ATTACHMENT 1

PROPOSED TECHNICAL SPECIFICATION CHANGE

SURRY POWER STATION

DISCUSSION OF
PROPOSED TECHNICAL SPECIFICATION CHANGE
SURRY POWER STATION

Offsite Organization for Facility Management and Technical Support

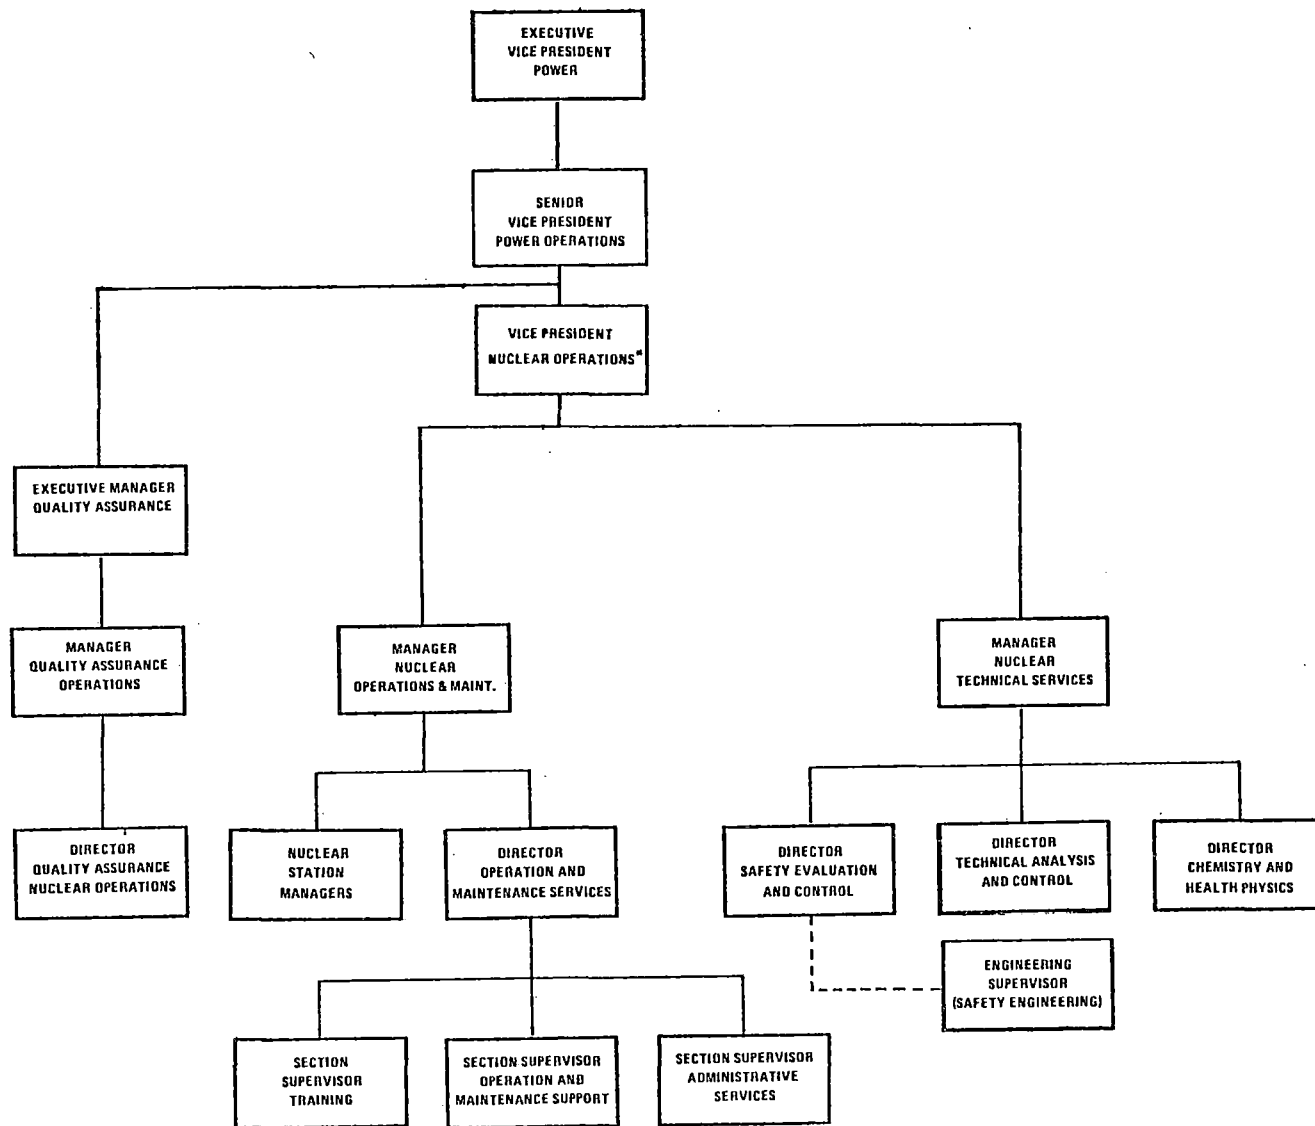
Technical Specifications Figure 6.1-1 has been revised to show the new structure of the offsite organization for facility management and technical support. Information provided by Figure 6.1-1 was previously provided by Figures 6.1-1 and 6.1-2. The previous positions of Senior Vice President-Power and Vice President-Power Supply and Production Operations have been deleted from the Technical Specifications. The deleted positions have been replaced by the Executive Vice President-Power, the Senior Vice President-Power Operations, and the Vice President-Nuclear Operations. All previous references to the Senior Vice President-Power and Vice President-Power Supply and Production Operations positions have been revised to reference either the Senior Vice President-Power Operations or the Vice President-Nuclear Operations positions.

As indicated by Figure 6.1-1, the Manager-Nuclear Operations and Maintenance and the Manager-Nuclear Technical Services replace the previous position of Director-Nuclear Operations. Both managers will report to the Vice President-Nuclear Operations. The Manager-Nuclear Operations and Maintenance has responsibility for the supervision of the Nuclear Station Managers in the operation and maintenance of the Company's operational nuclear units. Both Nuclear Station Managers and the Director-Operation and Maintenance Services report to the Manager-Nuclear Operations and Maintenance. The Director-Operation and Maintenance Services is responsible for coordinating operational and maintenance support with nuclear unit activities. The Section Supervisor-Training, the Section Supervisor-Operation and Maintenance Support, and the Section Supervisor - Administrative Services will report to the Director-Operation and Maintenance Services.

The Manager-Nuclear Technical Services has responsibility for technical services activities required to support the Company's operational nuclear units. Reporting to the Manager-Nuclear Technical Services are the Director-Chemistry and Health Physics, the Director-Technical Analysis and Control, and the Director-Safety Evaluation and Control. The Director-Chemistry and Health Physics will provide support to the nuclear stations in the areas of chemistry and health physics. The Director-Technical Analysis and Control is responsible for furnishing support for station design modifications and responses to NRC requirements. The Director-Safety Evaluation and Control, who is responsible for offsite safety review of nuclear power station operations, is discussed in greater detail below.

SURRY POWER STATION
ORGANIZATION CHART

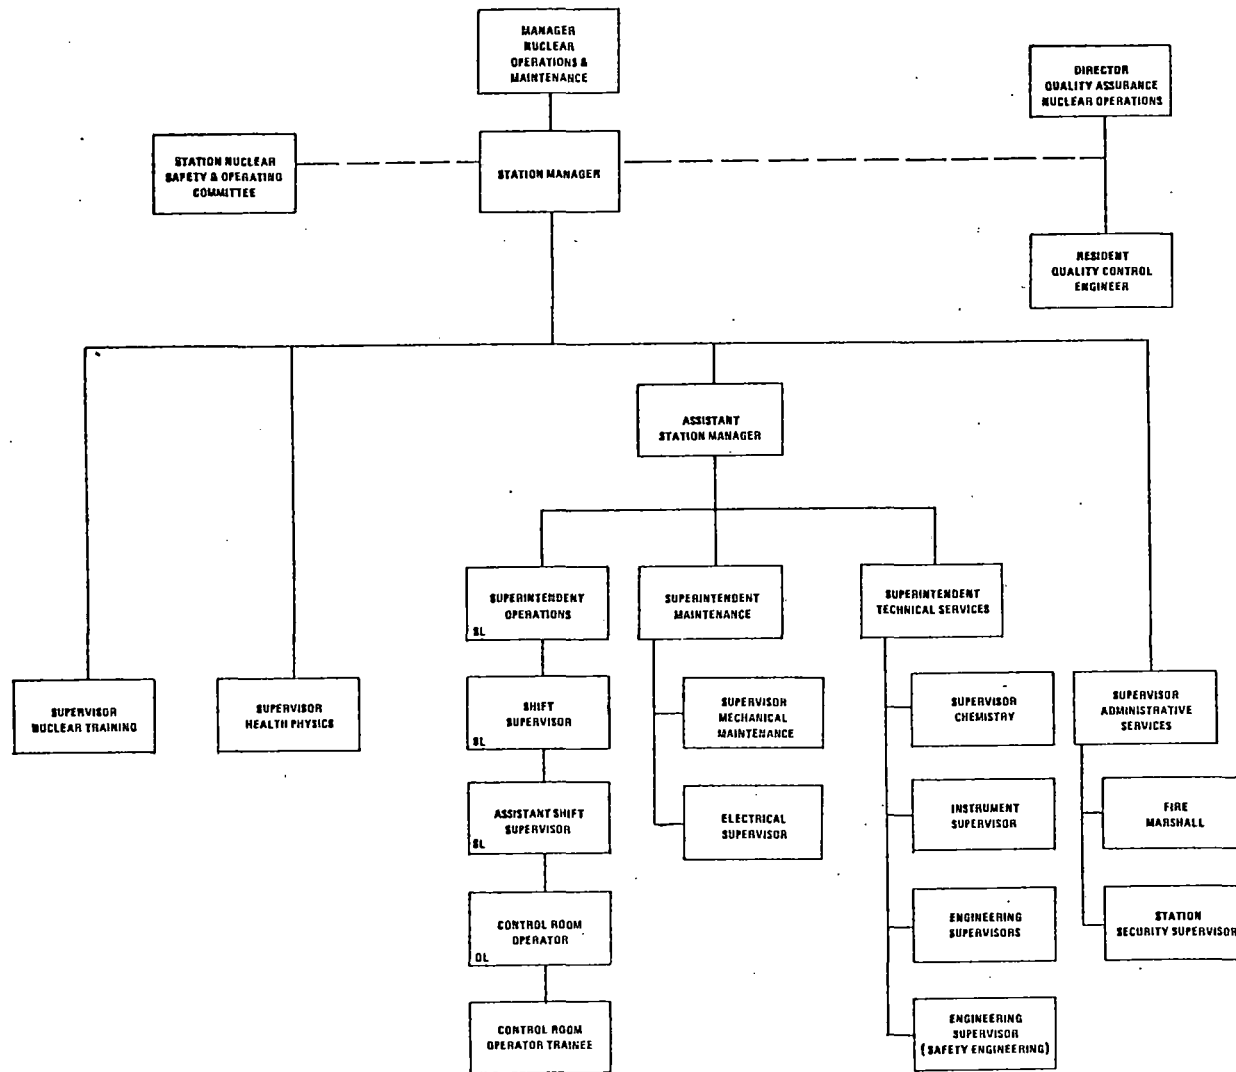
Technical Specification Figure 6.1-2 has been revised to show the new structure of the Surry Power Station organization. Figure 6.1-3, which previously provided this information, has been deleted. As explained above, the Station Manager reports to the Manager-Nuclear Operations and Maintenance. Our August 4, 1980 submittal (Serial No. 671) proposes revising Section 6.0 to add the new position of Assistant Station Manager to the Surry Power Station organization. The Assistant Station Manager will be directly responsible for the safe operation and maintenance of the power station. He will serve in a coordinating capacity to the Station Manager for the off-site activities of the Station. During the absence of the Station Manager, the Assistant Manager will act as the Station Manager. The Assistant Station Manager will also be the Vice Chairman of the Station Nuclear Safety and Operating Committee (SNSOC). The Superintendent-Operations, the Superintendent-Maintenance, and the Superintendent-Technical Services will report to the Assistant Station Manager. All three of these superintendents will remain members of the SNSOC.

The positions of Operating Supervisor and Auxiliary Operator have been eliminated from the organization chart. In addition, the position title of Assistant Control Room Operator has been revised to Control Room Operator Trainee. The positions of Maintenance Coordinator and Mechanical Supervisor have been replaced on the station organization chart by the position of Supervisor-Mechanical Maintenance. Both the Maintenance Coordinator and the Mechanical Supervisor report to the Supervisor-Mechanical Maintenance. Other title changes made to the organization chart include the change of Supervisor-Safety Engineering to Engineering Supervisor (Safety Engineering), the change of Engineering Supervisor to Engineering Supervisors to reflect the two positions of Engineering Supervisor-Performance and Tests and Engineering Supervisor-Design Changes and Projects and, the change of Training Supervisor to Supervisor-Nuclear Training. The Supervisor-Health Physics position has been shifted such that he will now report directly to the Station Manager instead of reporting to the Superintendent-Technical Services. The positions of Supervisor-Nuclear Training and Supervisor-Administrative Services will also report to the Station Manager.
